**ADDENDUM 1**

Marathon County Public Library  
Restroom Renovation  
300 North 1<sup>st</sup> Street  
Wausau WI 54403

Commission No.: O25037  
Addendum Date: August 7, 2025

SECOND FLOOR RESTROOM PLANS

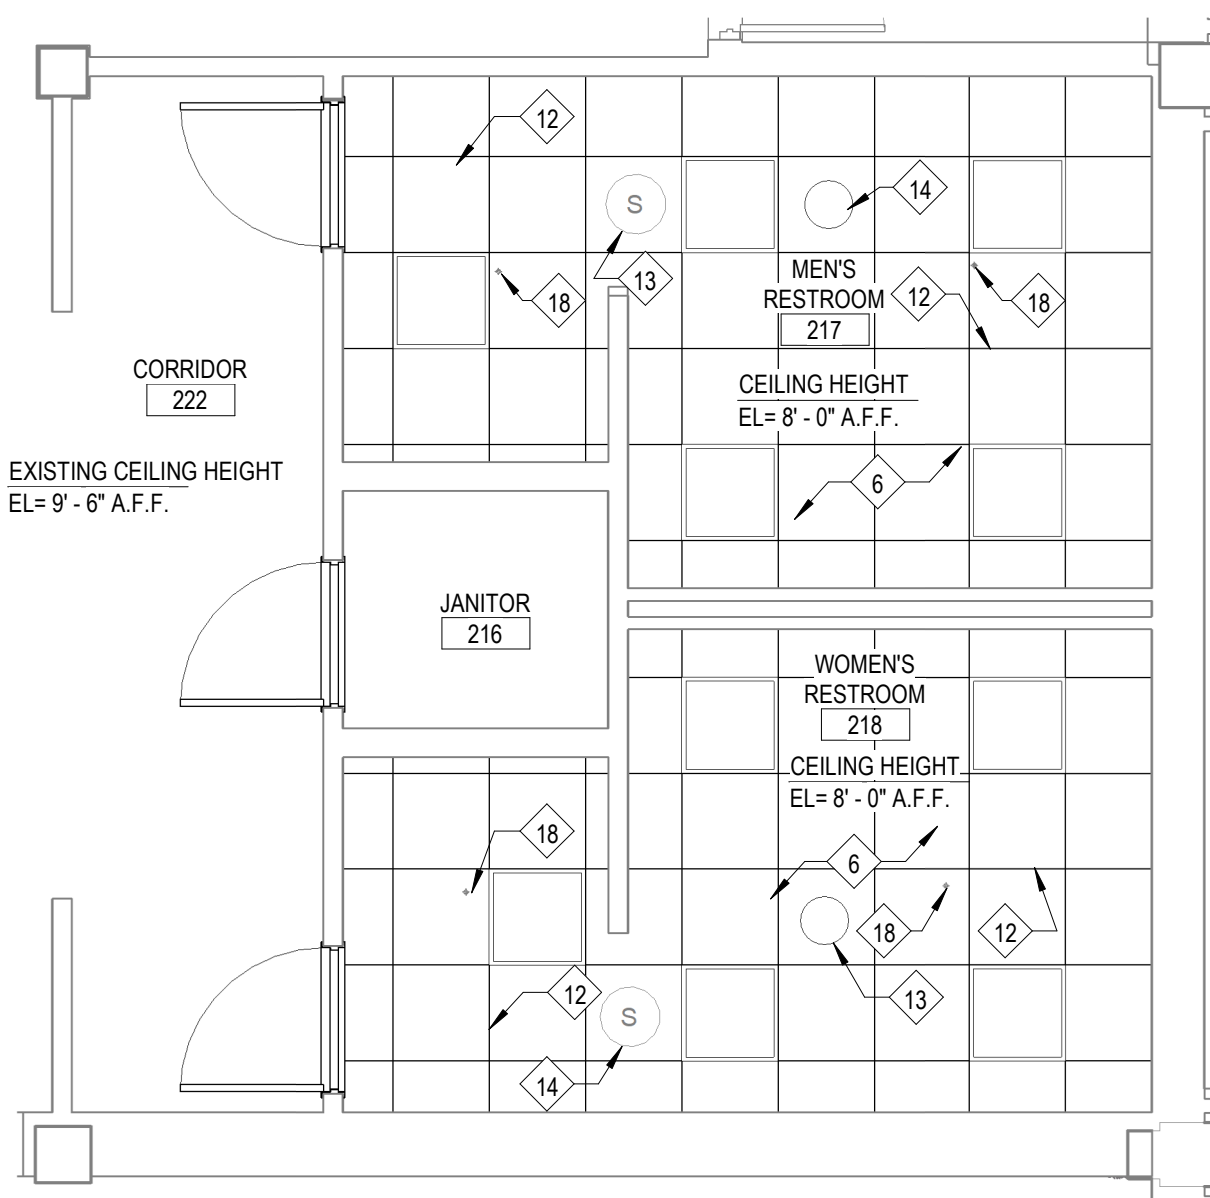
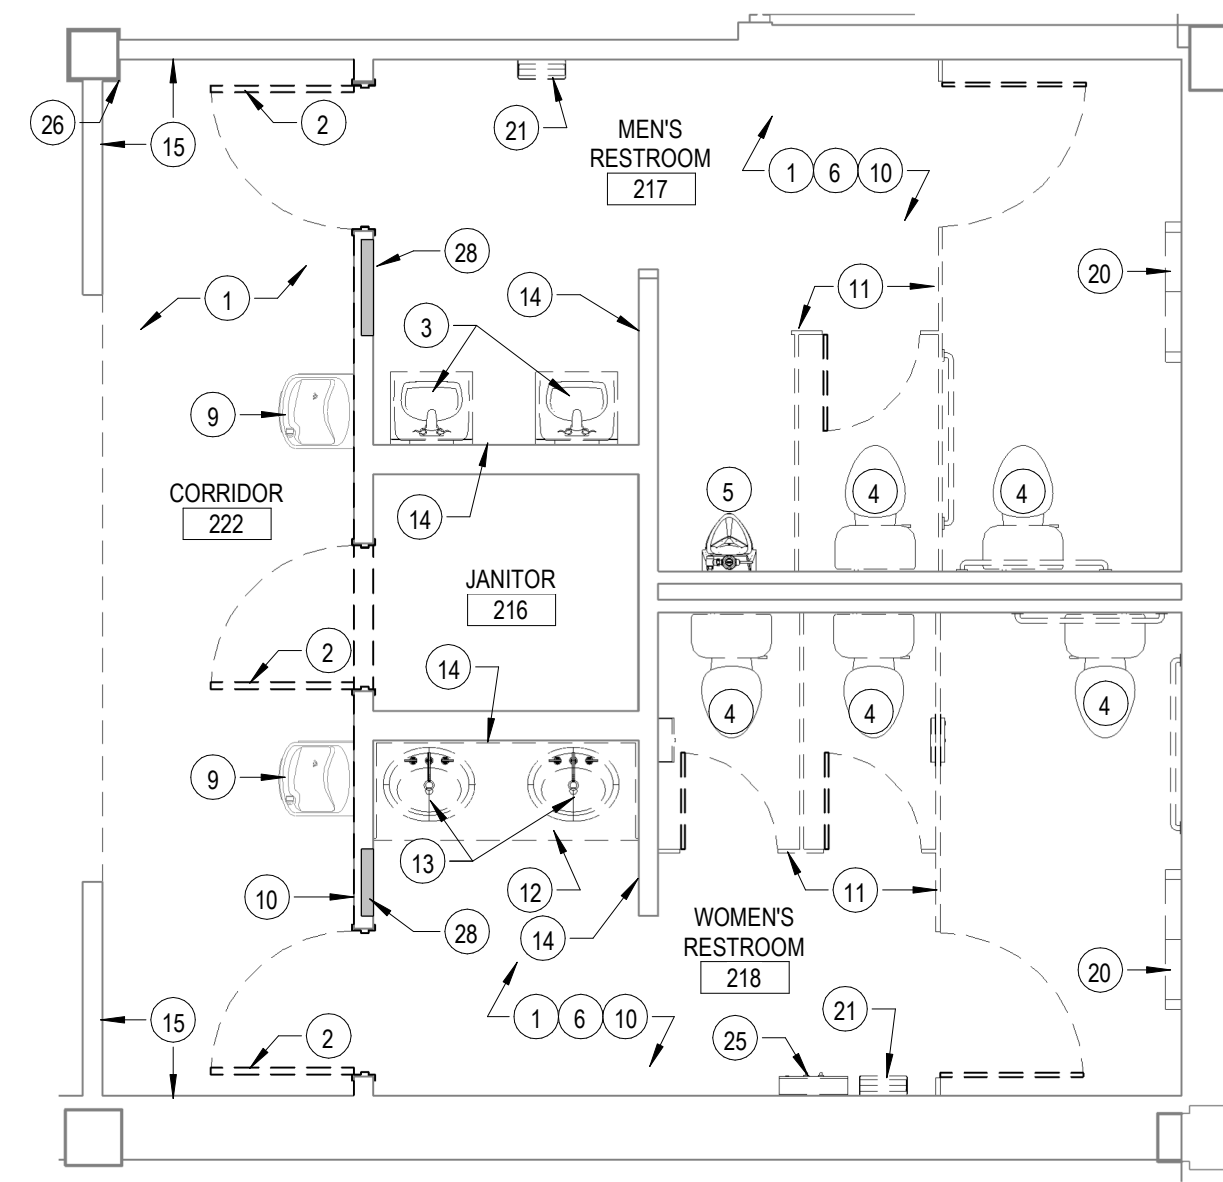
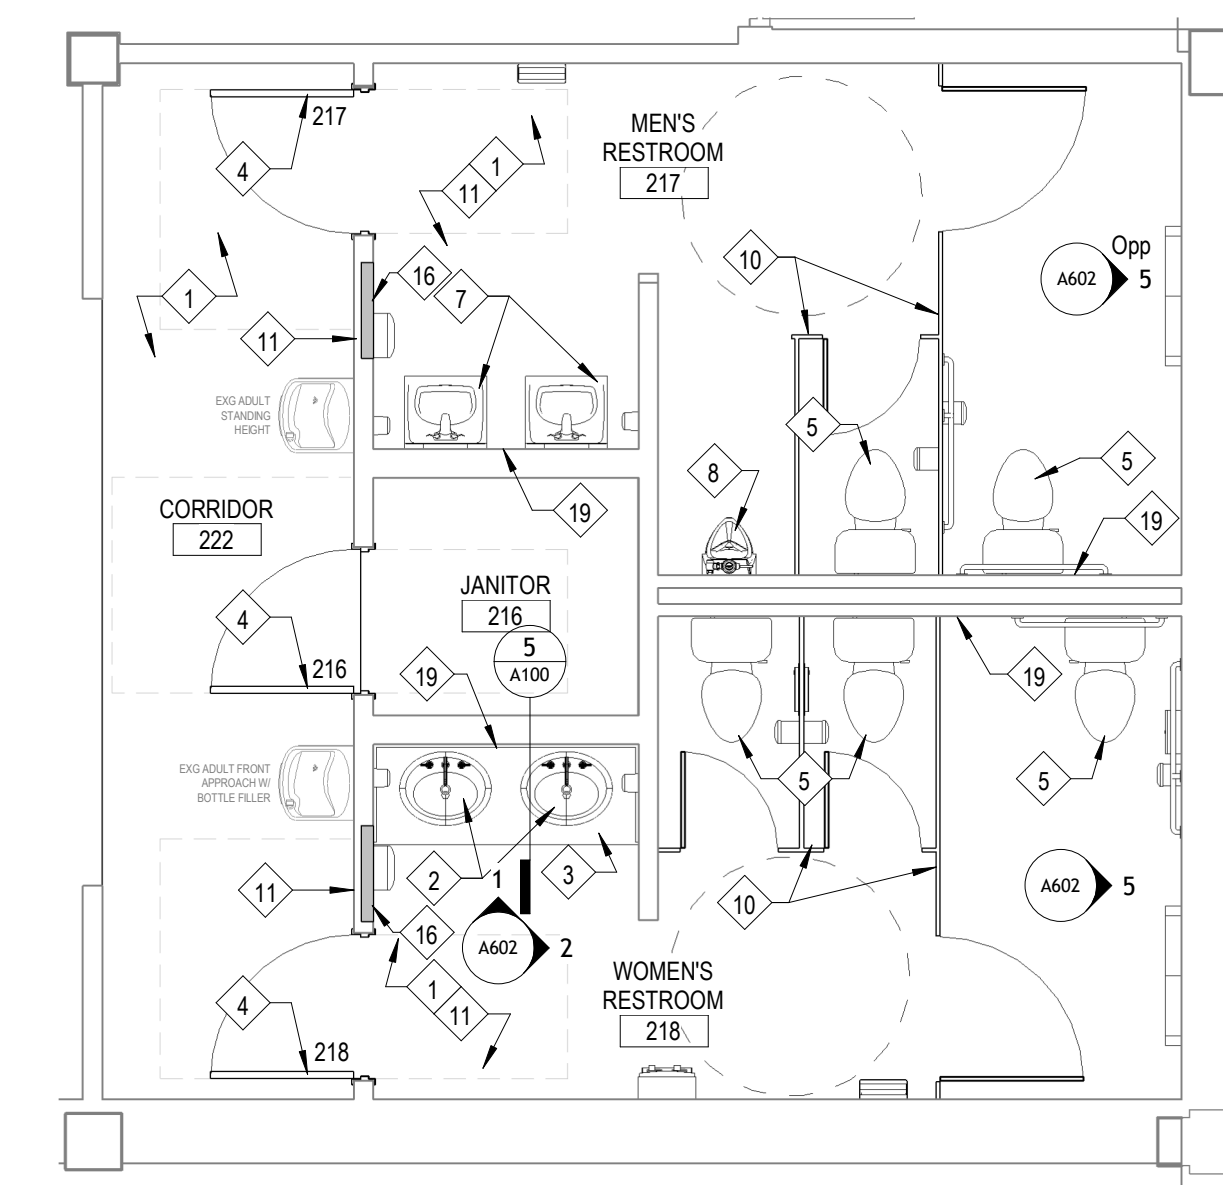
- a) Demolition Note 3: REVISE to state the following: “Remove existing lavatories and faucets; prepare existing HW, CW, and SAN pipes to accommodate installation of new. Provide temporary seal for sanitary pipes for duration of construction.”

- b) Demolition Note 13: REVISE to state the following: “Remove existing drop-in sinks and faucets; prepare existing HW, CW, and SAN pipes to accommodate installation of new. Provide temporary seal for sanitary pipes for duration of construction.”

- c) Work Description Note 2: REVISE to state the following: “Provide new American Standard ‘Aqualyn’ model 0475.047 drop-in sink with new Sloan ‘Optima’ model EAF-350-BAT-ISM-CP-0.5GPM-AER-IQ-FCT faucet. Provide new grid strainer drain, P-trap, and trap arm. Extend/rework existing CW, HW, and SAN pipes as required for connection.”

- d) Work Description Note 7: REVISE to state the following: “Provide new American Standard ‘Lucerne’ model 0356.421 wall-hung lavatory with new Sloan ‘Optima’ model EAF-350-BAT-ISM-CP-0.5GPM-AER-IQ-FCT faucet. Provide new grid strainer drain, P-trap, and trap arm. Extend/rework existing CW, HW, and SAN pipes as required for connection. If existing fixture carrier or wall hanger is not suitable for re-use, notify the Architect.”

**A104**  
 THIRD FLOOR RESTROOM PLANS

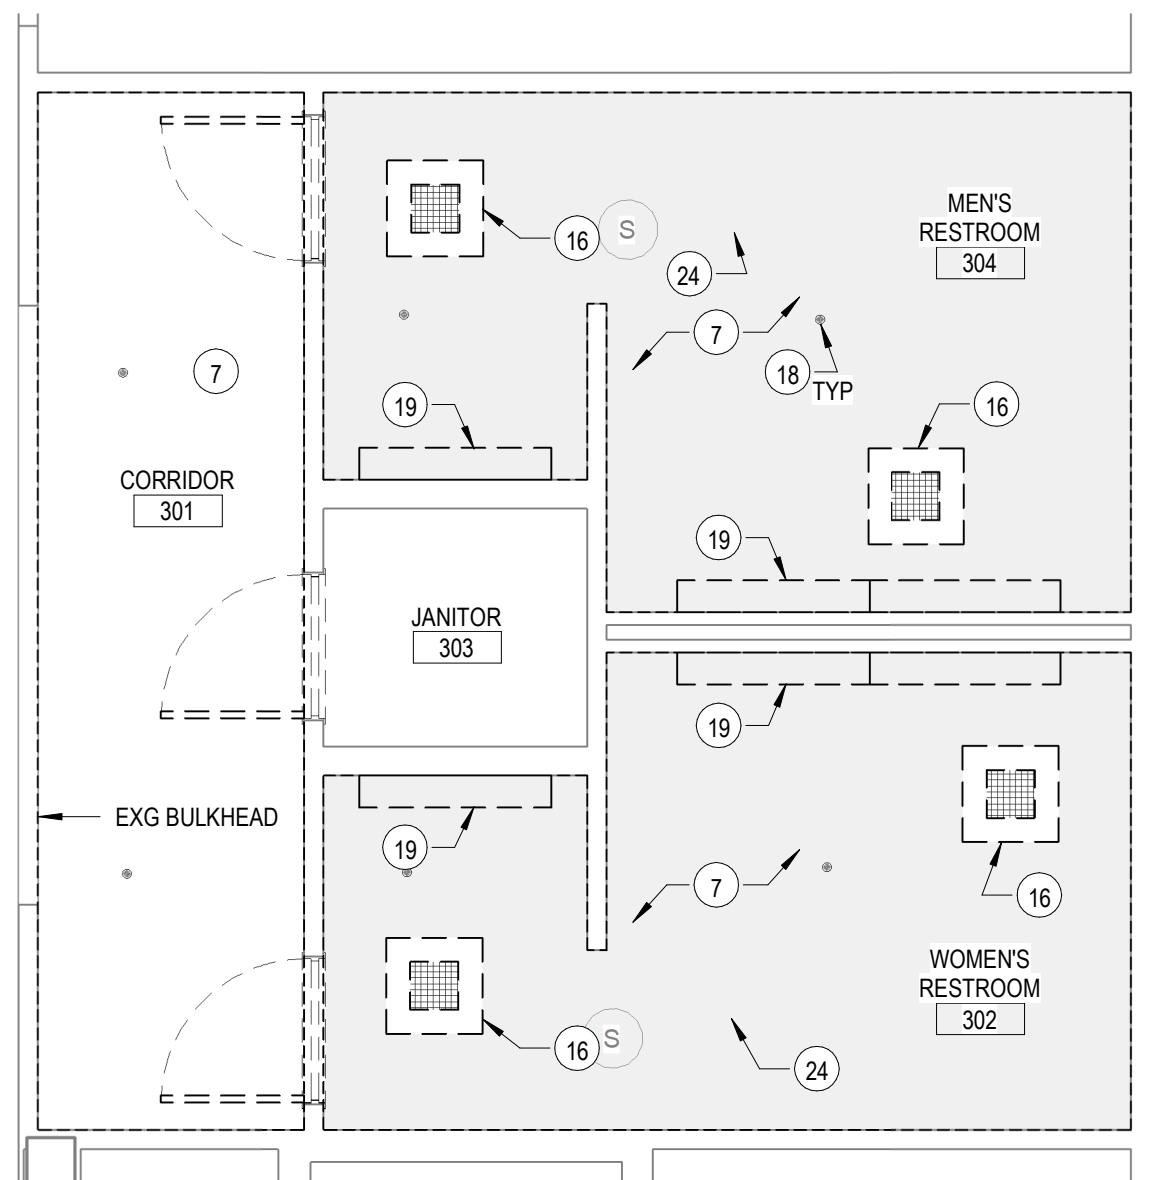
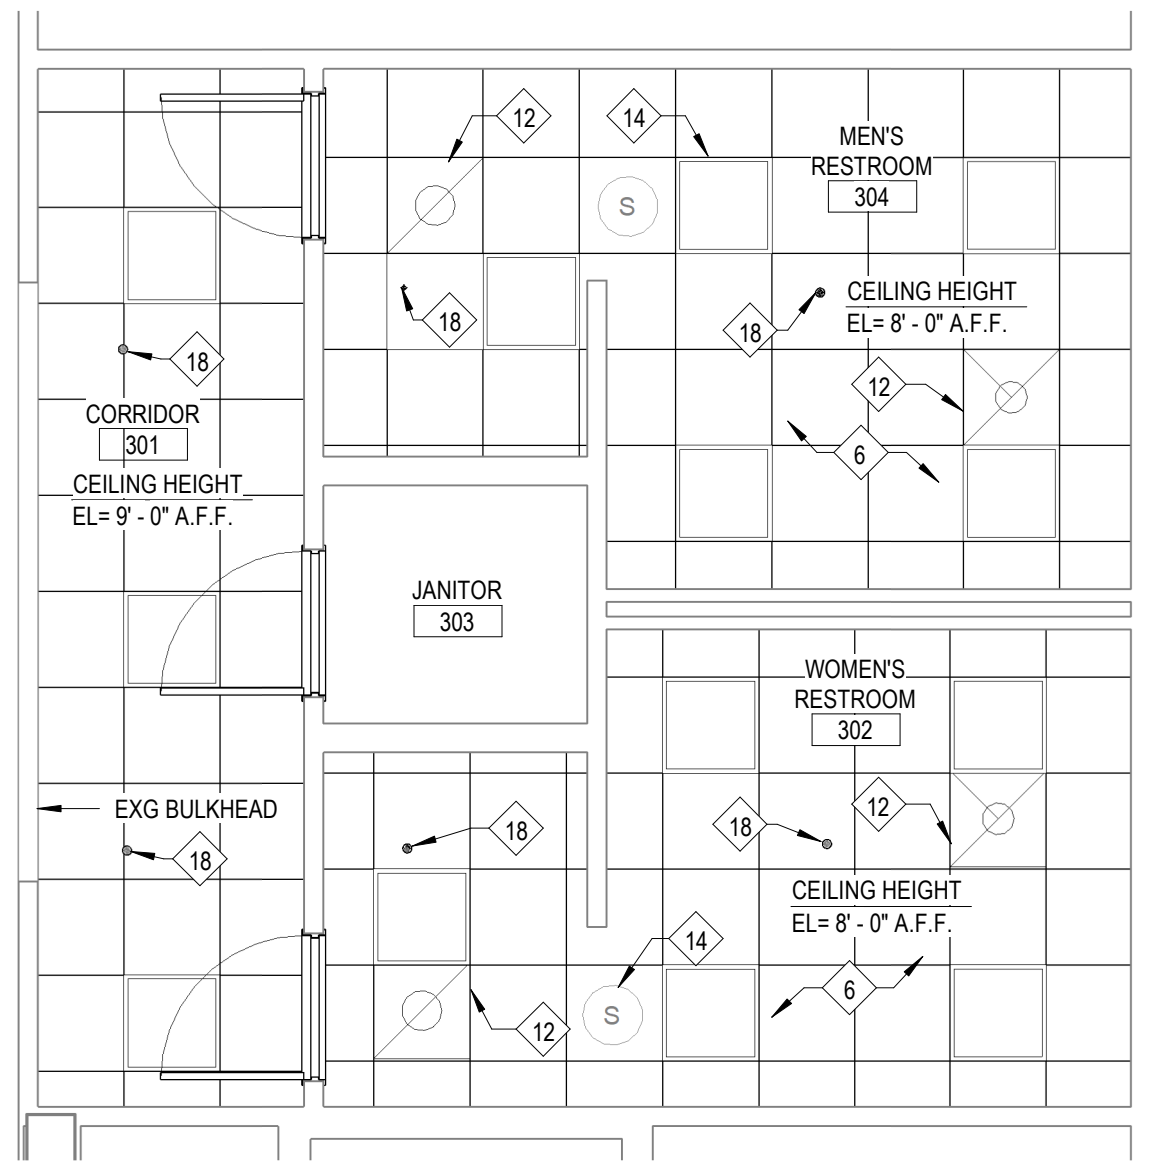
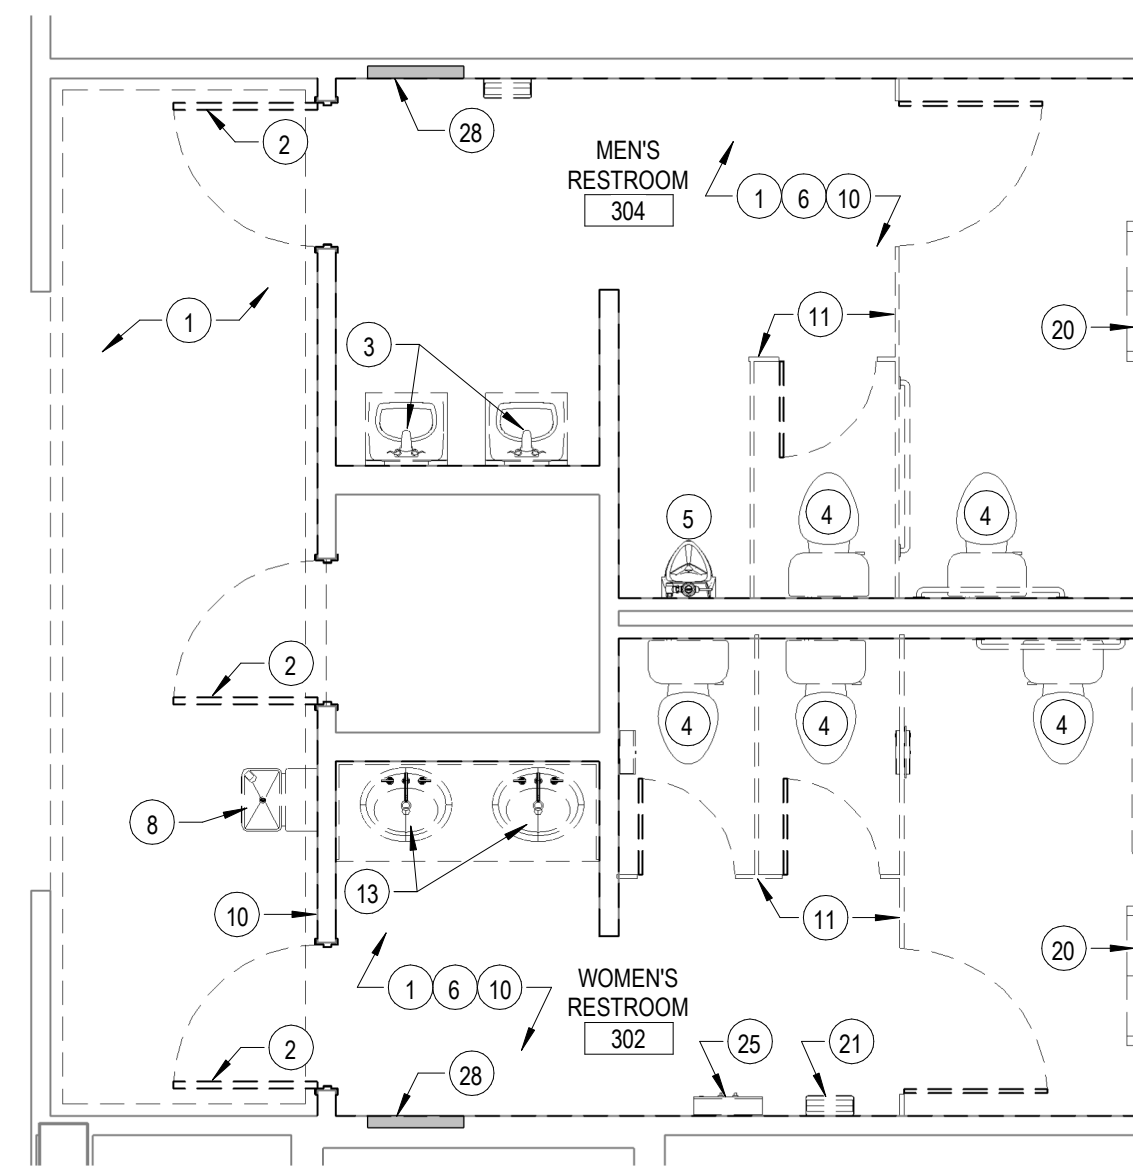
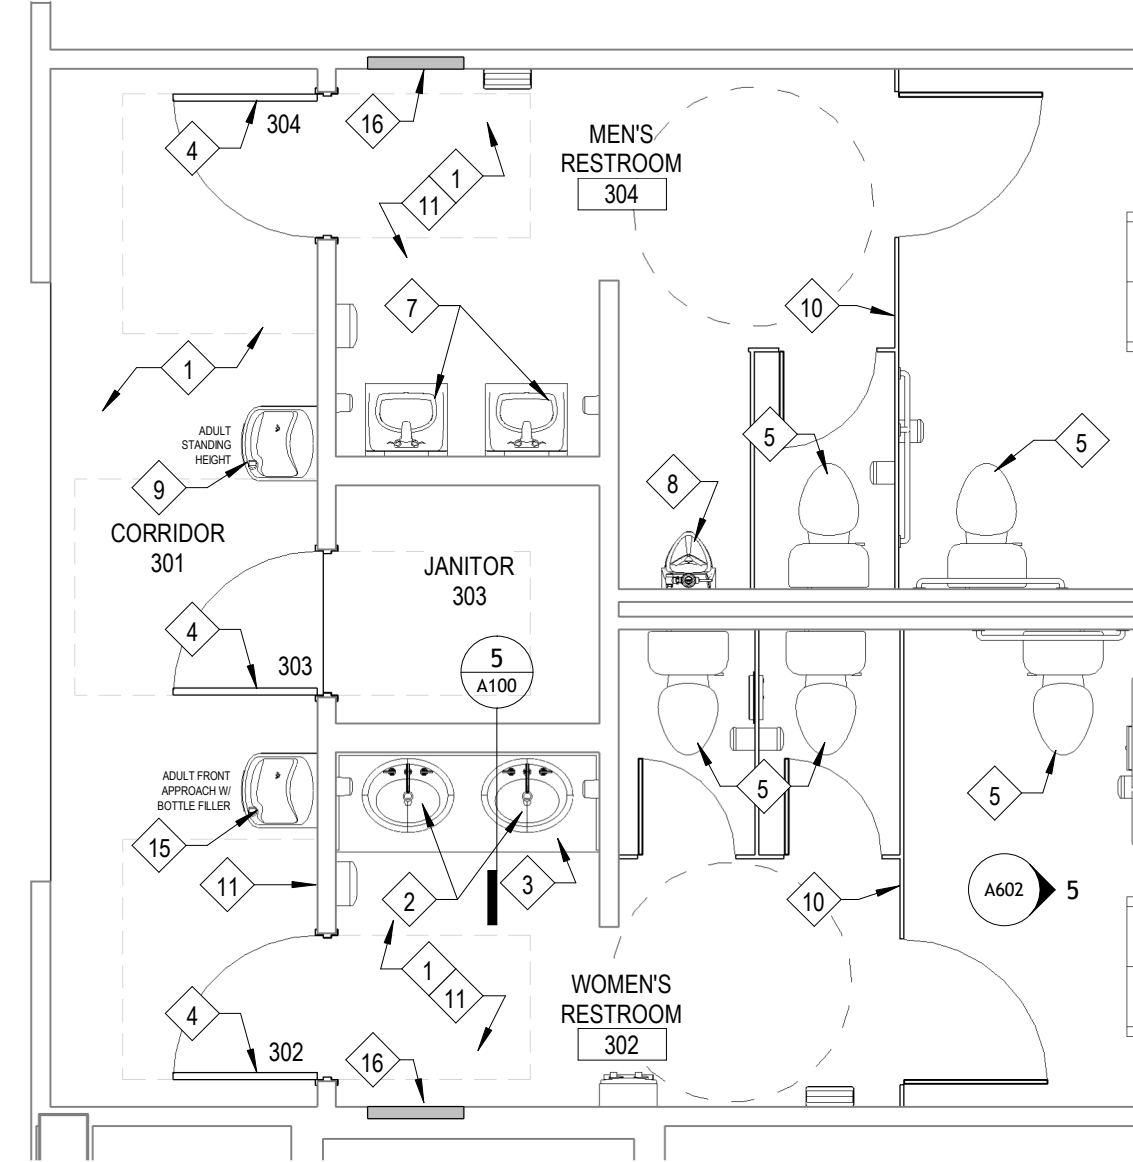
- 5) A104 Third Floor Restroom Plans
- a) Demolition Note 3: REVISE to state the following: “Remove existing lavatories and faucets; prepare existing HW, CW, and SAN pipes to accommodate installation of new. Provide temporary seal for sanitary pipes for duration of construction.”

- b) Demolition Note 13: REVISE to state the following: “Remove existing drop-in sinks and faucets; prepare existing HW, CW, and SAN pipes to accommodate installation of new. Provide temporary seal for sanitary pipes for duration of construction.”

- c) Work Description Note 2: REVISE to state the following: “Provide new American Standard ‘Aqualyn’ model 0475.047 drop-in sink with new Sloan ‘Optima’ model EAF-350-BAT-ISM-CP-0.5GPM-AER-IQ-FCT faucet. Provide new grid strainer drain, P-trap, and trap arm. Extend/rework existing CW, HW, and SAN pipes as required for connection.”

- d) Work Description Note 7: REVISE to state the following: “Provide new American Standard ‘Lucerne’ model 0356.421 wall-hung lavatory with new Sloan ‘Optima’ model EAF-350-BAT-ISM-CP-0.5GPM-AER-IQ-FCT faucet. Provide new grid strainer drain, P-trap, and trap arm. Extend/rework existing CW, HW, and SAN pipes as required for connection. If existing fixture carrier or wall hanger is not suitable for re-use, notify the Architect.”
